Title: TOP & POWER

Project: NUCLEO-XXXXXXX			
Size: A4	Reference: MB1136	Revision: C.3	
Date: 9/26/2014		Sheet: 1 of 4	life.augmented

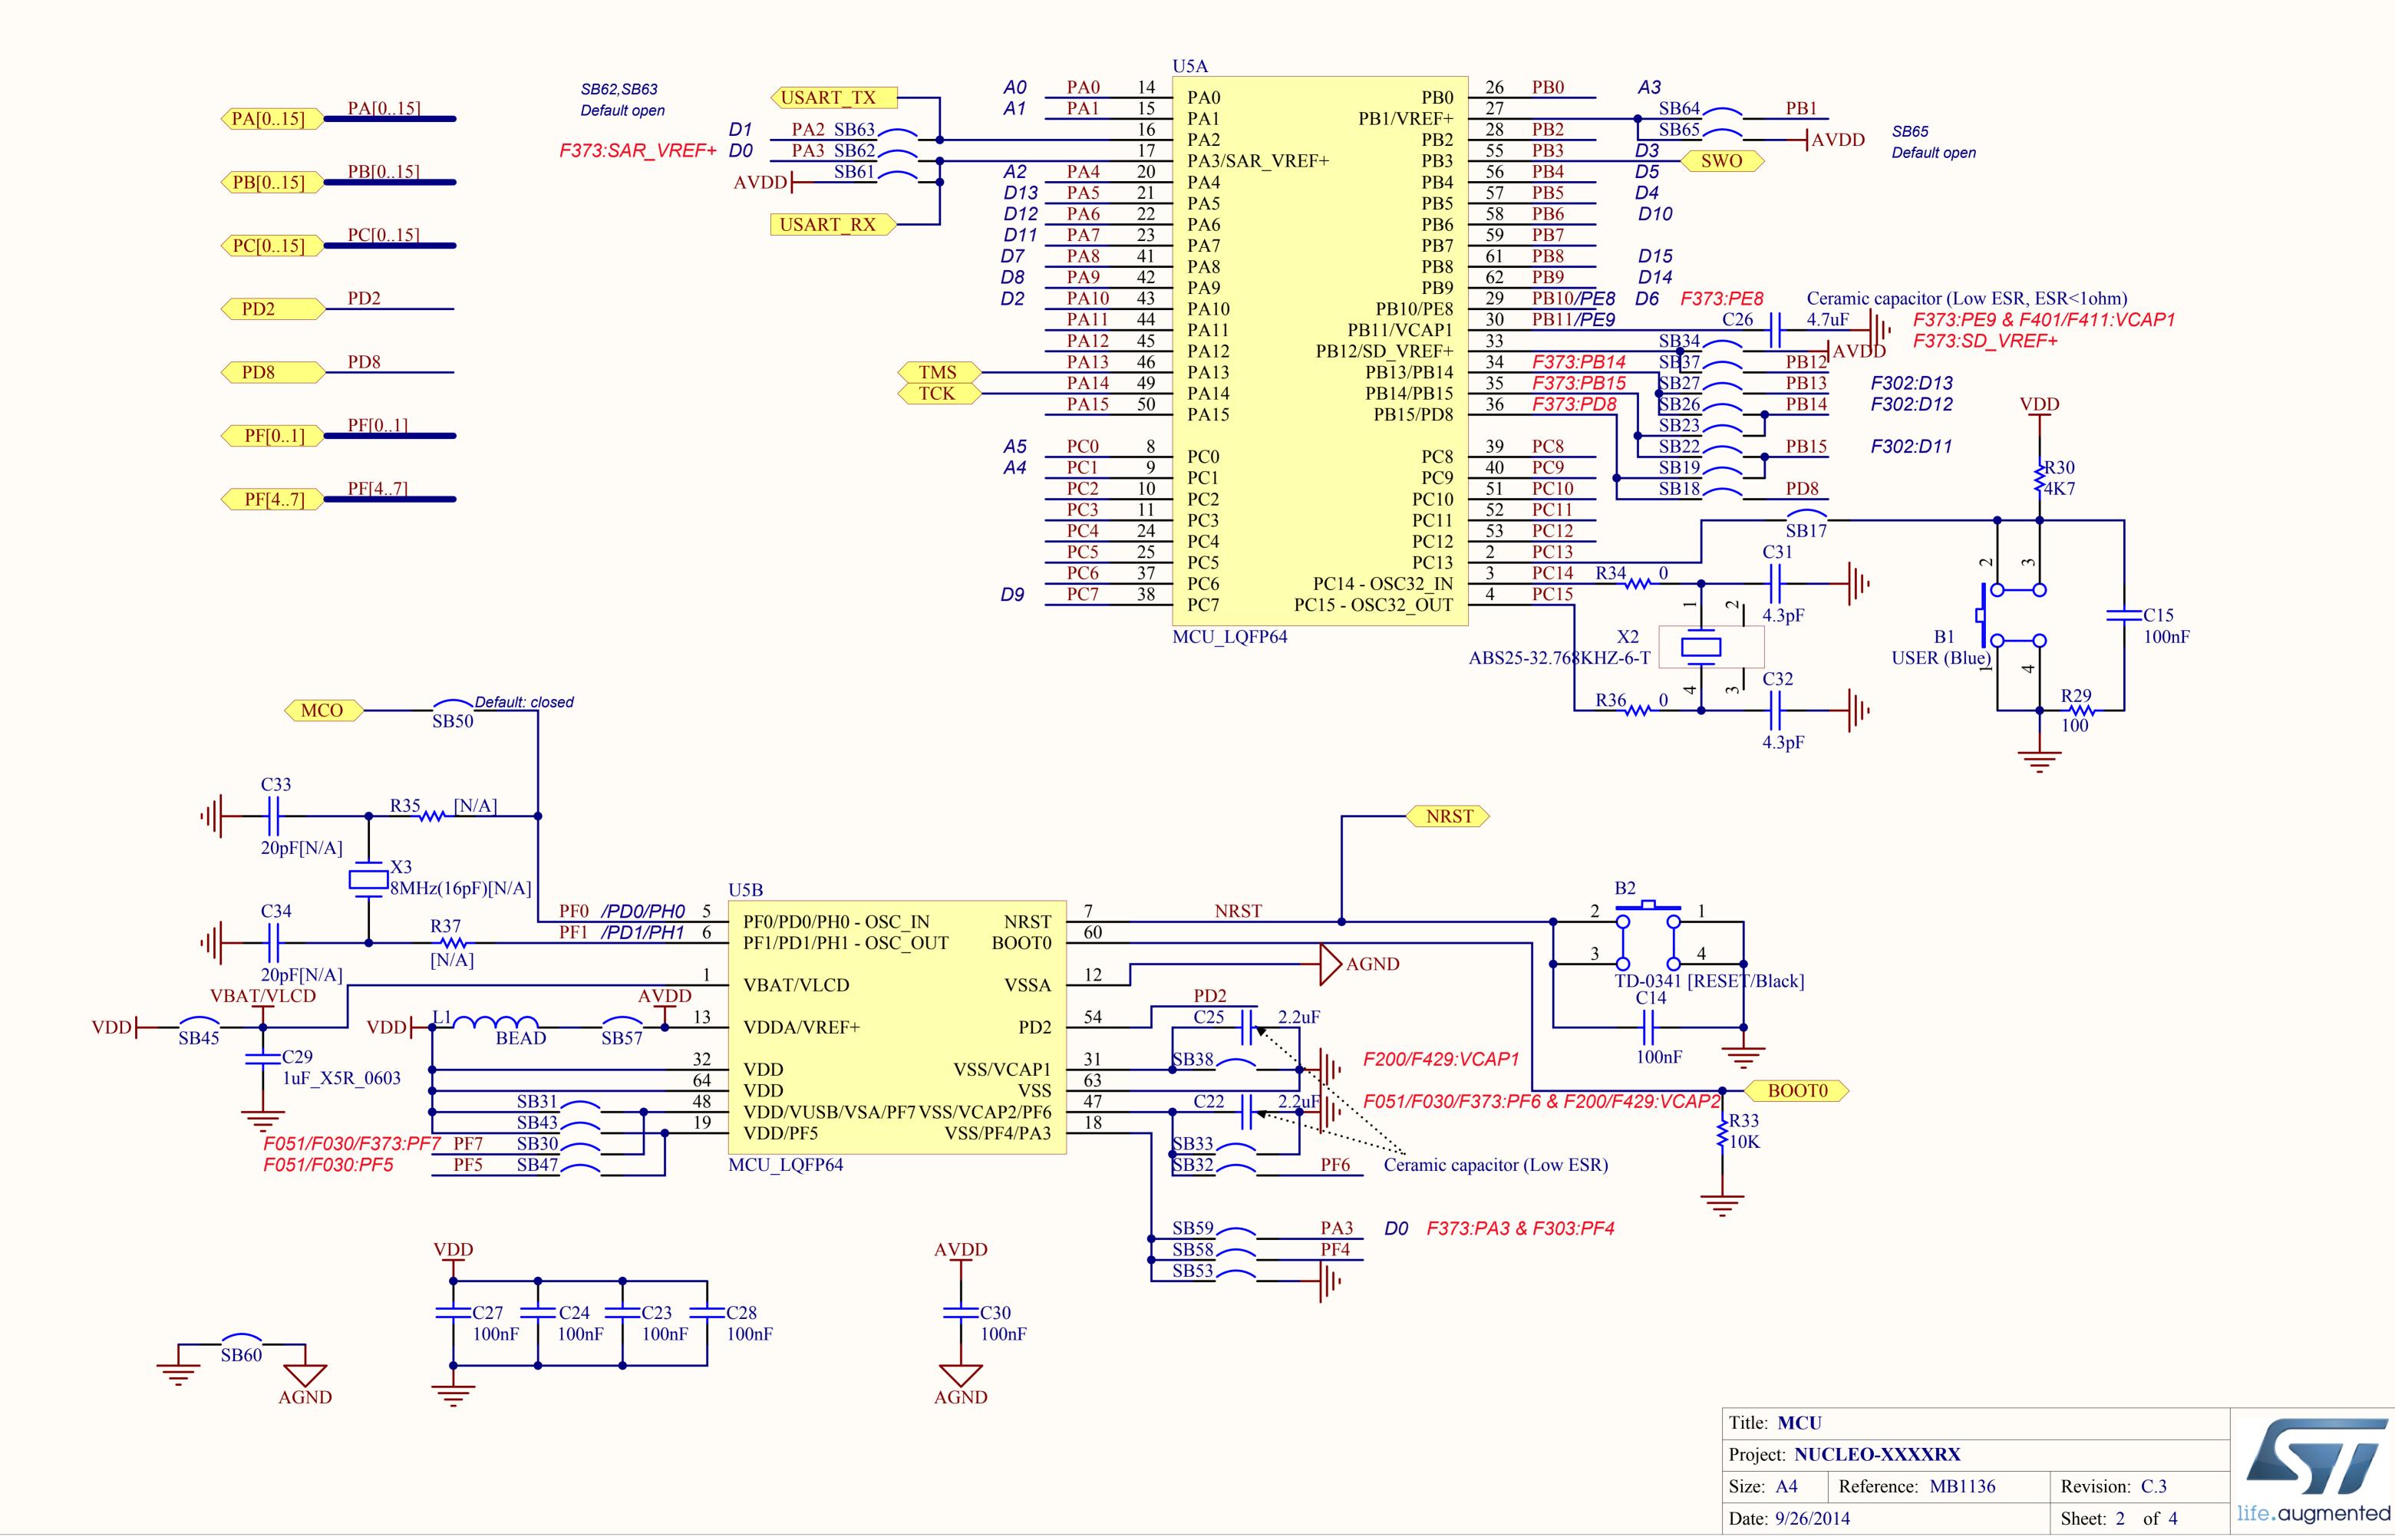
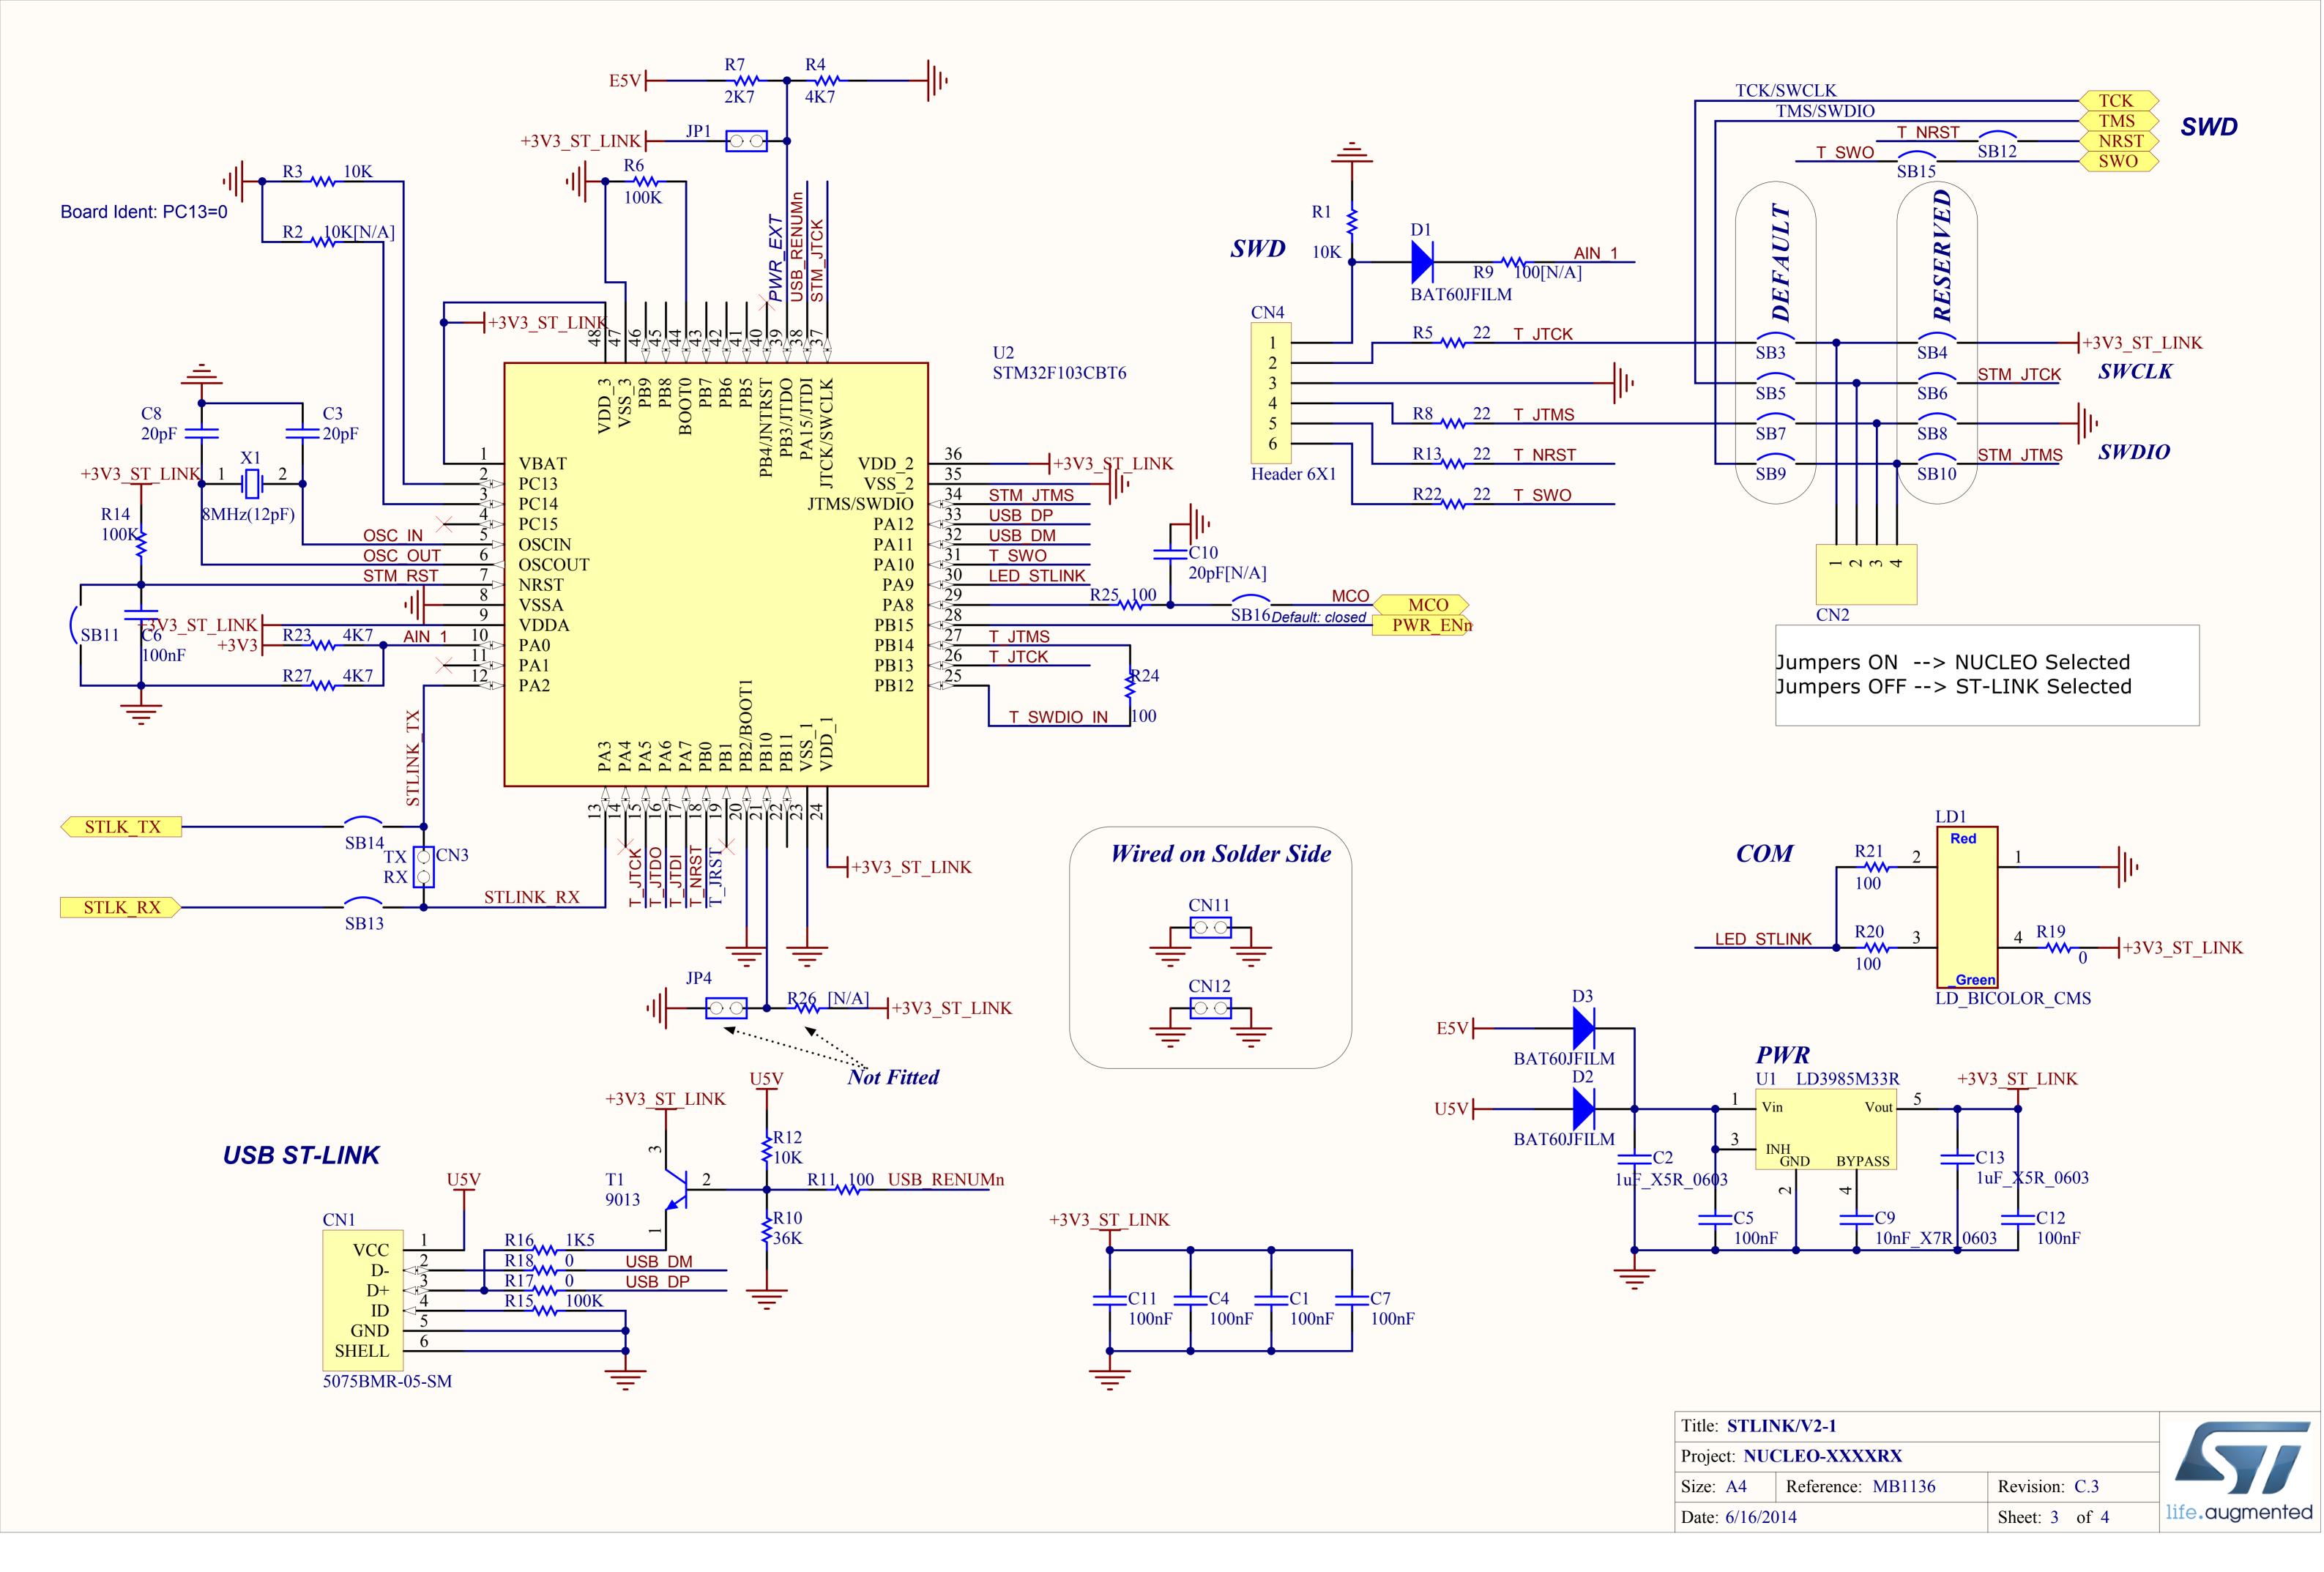
Note2: Remove [N/A] on R34, R36, C31, C32, X2 from C.1 to C.2

Note3: Add "default open" on SB48, SB49, SB55 from C.1 to C.2

Note4: Replace "default open" by "default closed" on SB16 & SB50 from C.1 to

Note5: C31&C32 value changed from 10pF to 4.3pF to fit with new 32K crystal ABS25-32.768KHZ-6-T
